AMENDMENTS TO THE DRAWINGS:

REMARKS

MARKED-UP SHEET

Fig. 1
Prior Art

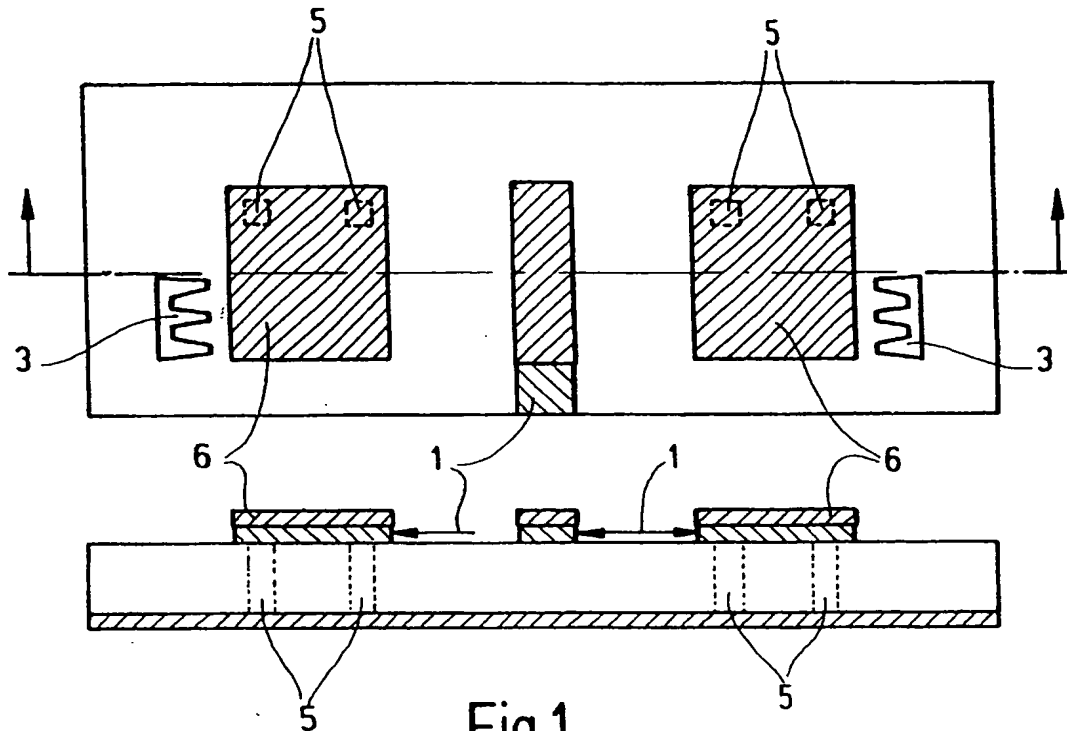
Please label Fig. 1 with the legend "*prior art*" as indicated on the marked-up and replacement sheets set forth in the Appendix following page 7 herein.

The legend “*Prior Art*” was added to Fig. 1, as required.
